Date November 15, 2018
To Town of Cumberland Planning Board
From Carla Nixon, Town Planner
Subject **Major Subdivision Amendment: Orchard Road - 10 Lot Subdivision**

The applicant is TZ Properties. The applicant is requesting approval of a subdivision amendment to a previously approved 10 lot clustered subdivision on Orchard Road. The proposed amendment reflects the relocation of the former Lot # 10 to a new location. This amendment does not increase the number of lots, the amount of open space or the roadway layout. The lots will be served by private water and septic systems. The 24.9 acre parcel is located on Orchard Road (approximately 750' south of the intersection with Whitney Road) and is shown on Tax Assessor Map R-08, Lot 59 and on a portion of Map R08, Lot 59B in the Rural Residential 2 (RR 2) zoning district. Will Haskell, P.E. of Gorrill Palmer Engineers is the Applicant's representative.

Drawing No.

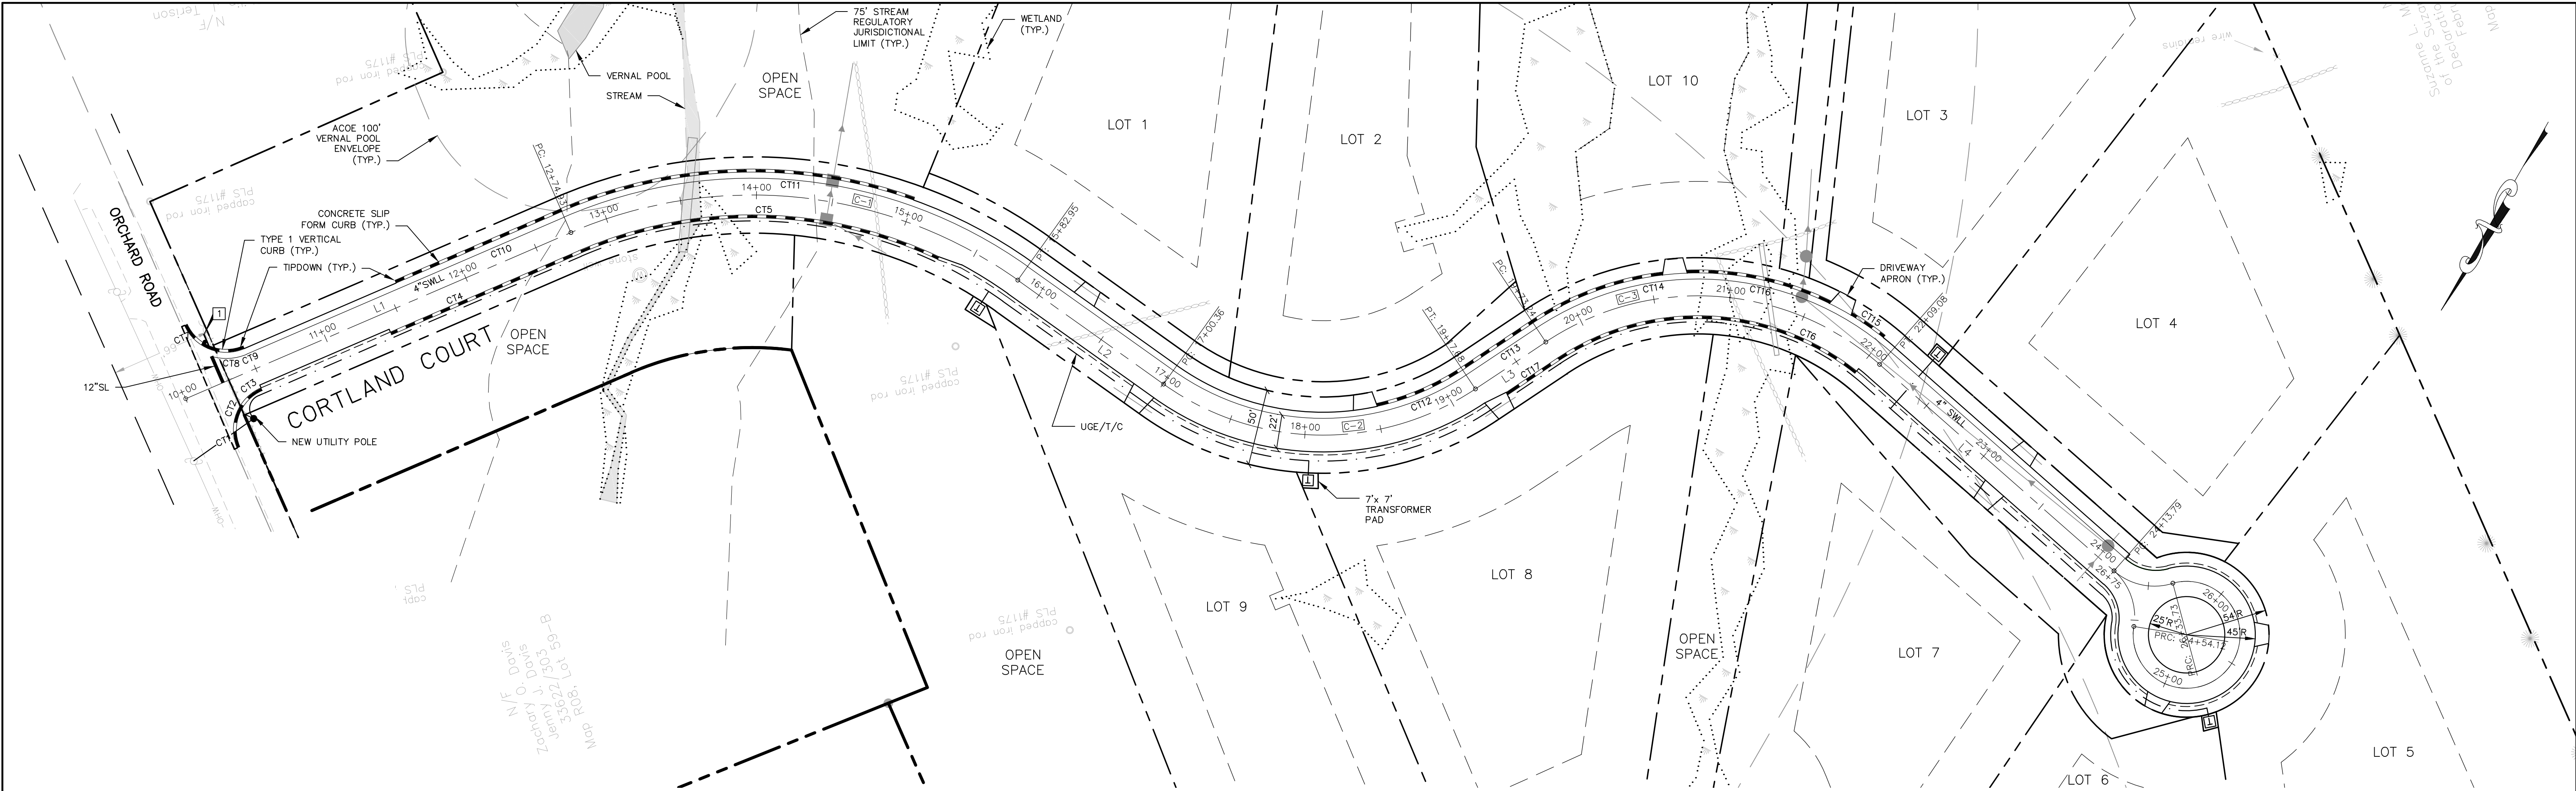
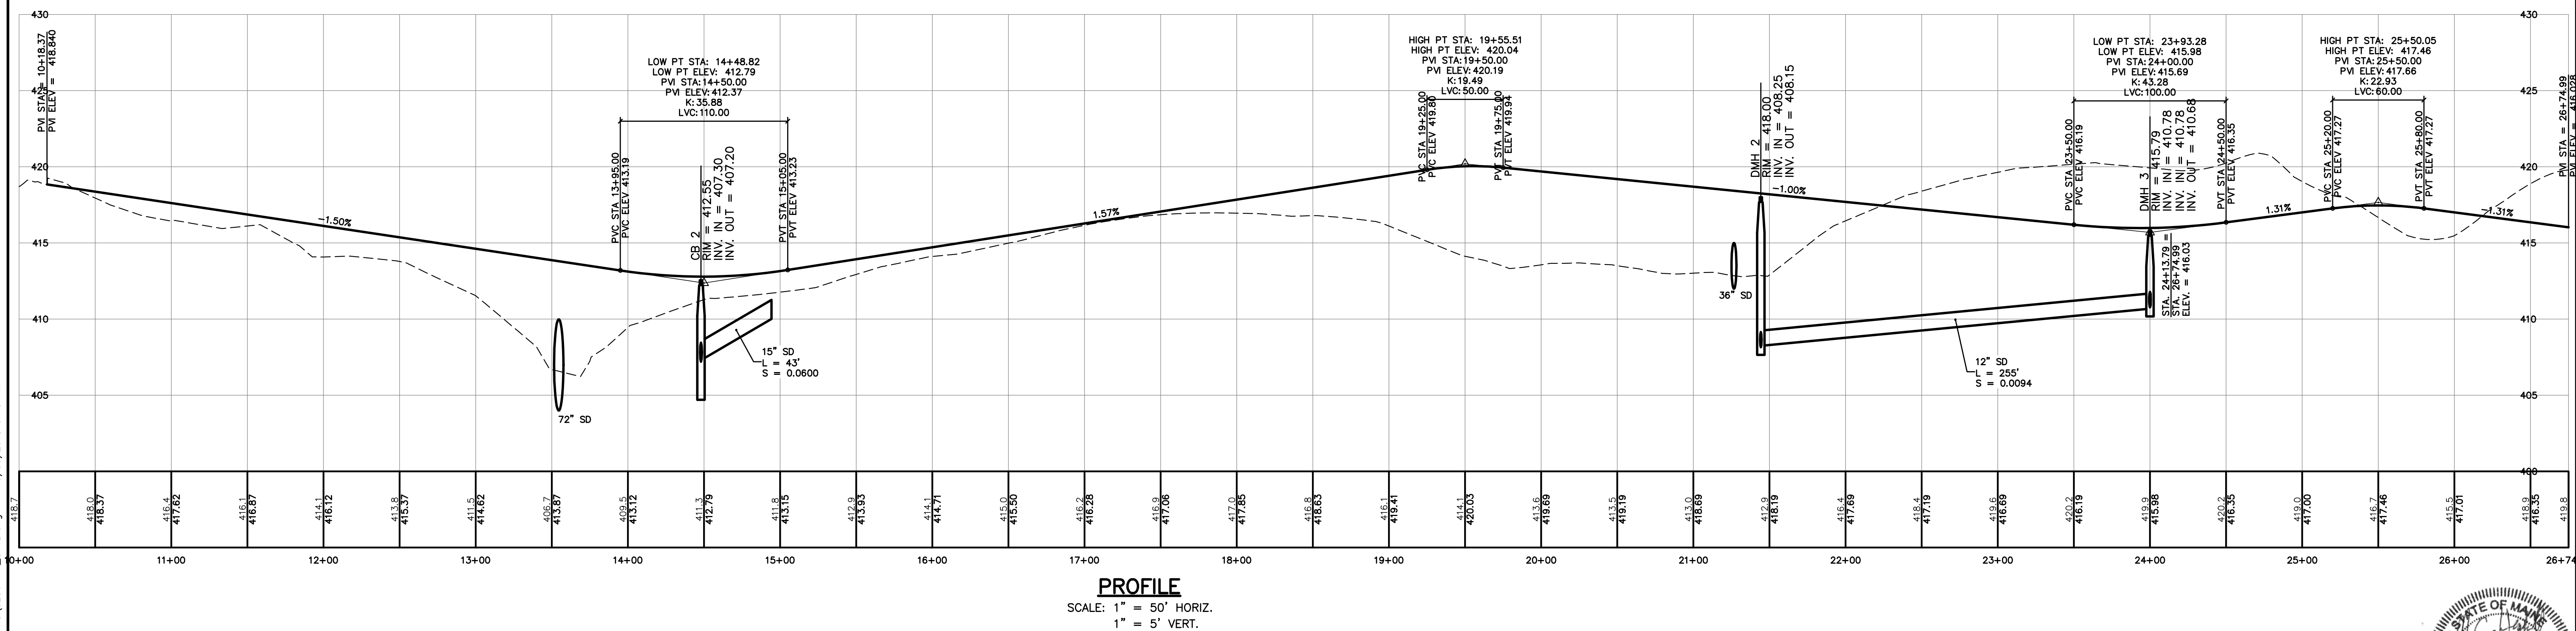
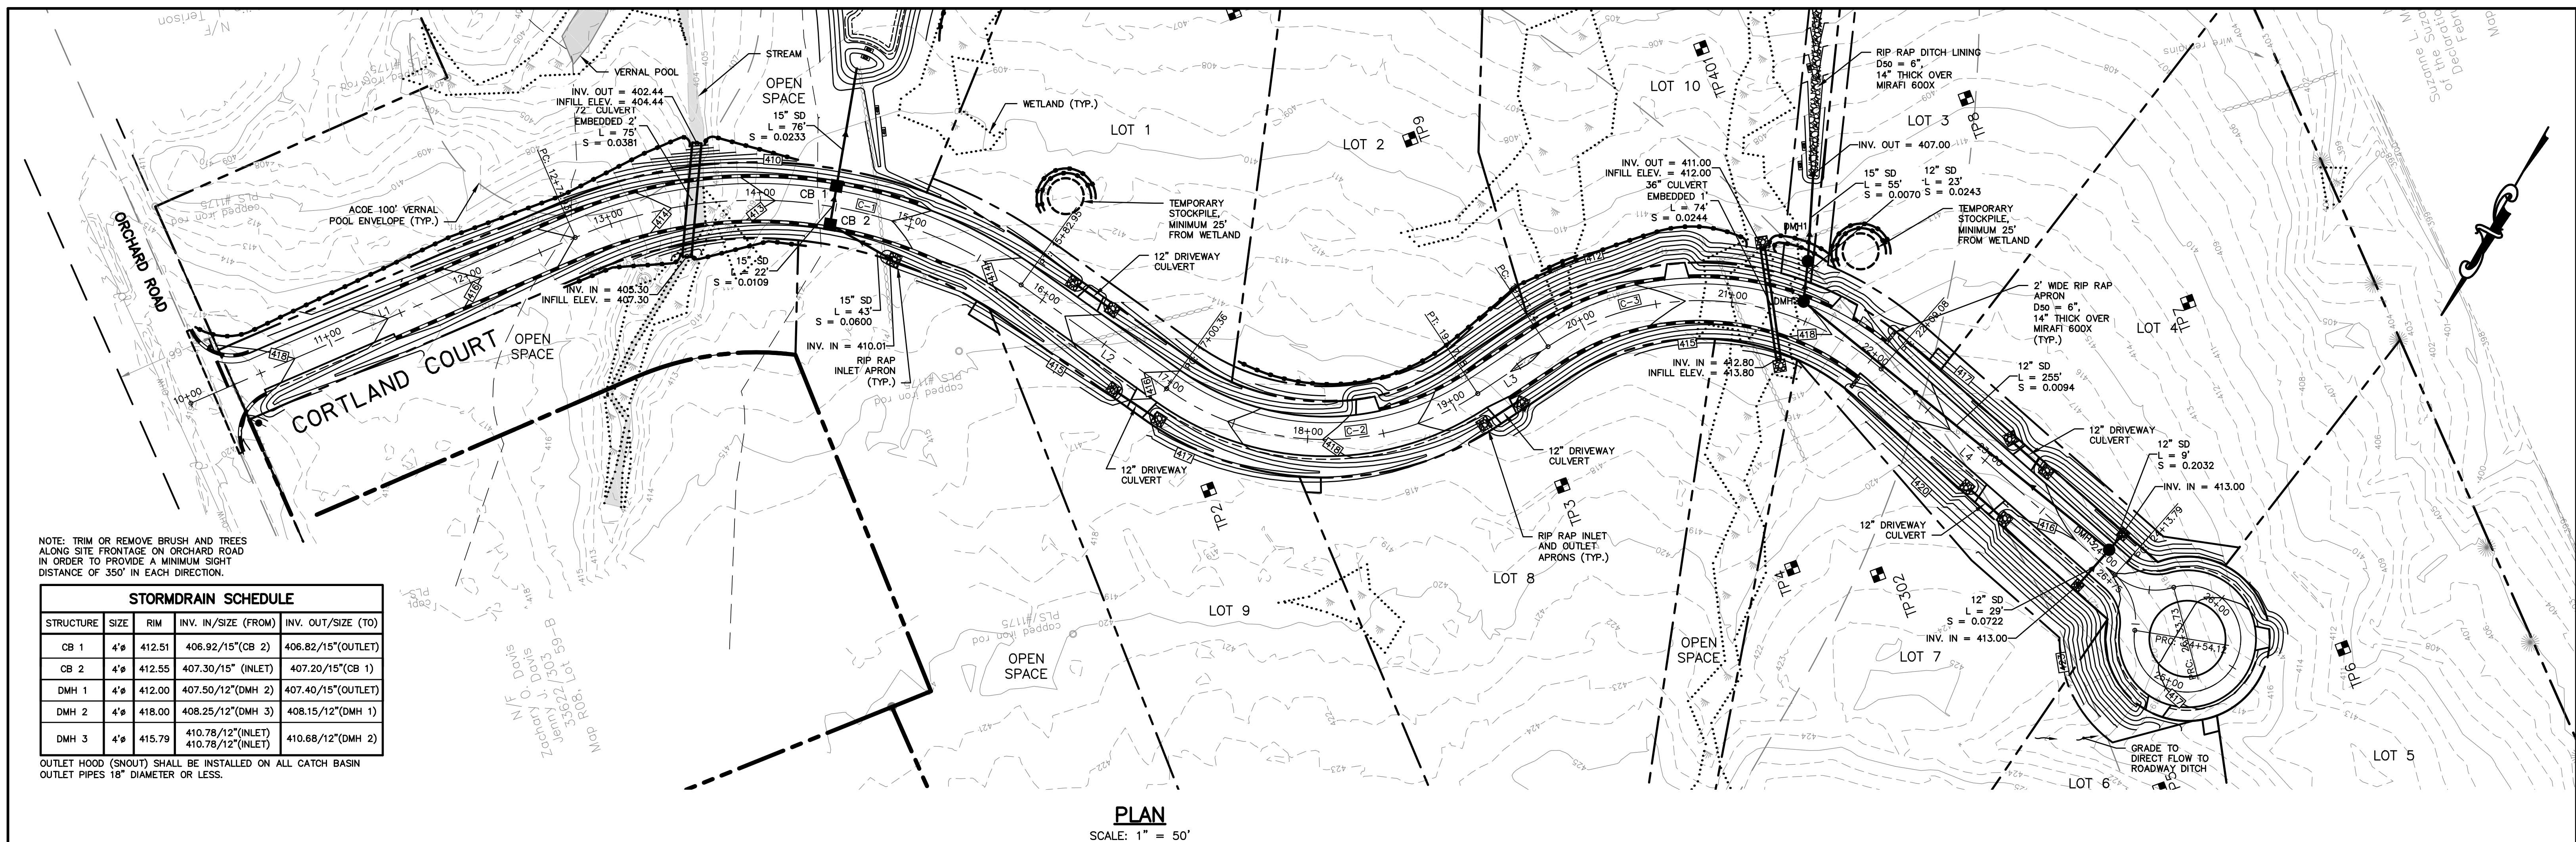
1. The curb locations shown on the road sections on Drawing No. 10 do not appear to match the curb locations shown on Drawing No. 7.

1. The curb locations shown on the road sections on Drawing No. 10 do not appear to match the curb locations shown on Drawing No. 7.
2. Please verify the side setback for lot 10 near the southwest property corner is 30 feet (minimum) from the property line.

Response: Drawing 10 will be revised to reflect the curb locations shown on Drawing 7.
